TECHNICAL BULLETIN

TECHNICAL BULLETIN: 11-06

SUBJECT: Revision to Replacement Cable for 96XX Power Supplies

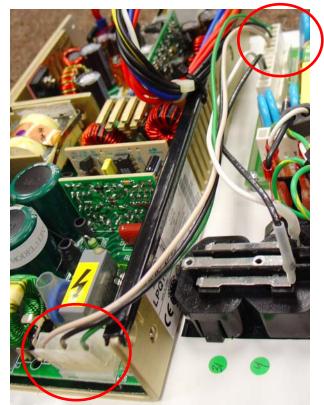
DO NOT be tempted to turn the connector around and install in the reverse manner.

The cable is routed from the power supply to the surge protector as shown.

If your 96XX requires a new cable, the replacement cable number is **09600-00011** and is available from Triton at no charge.
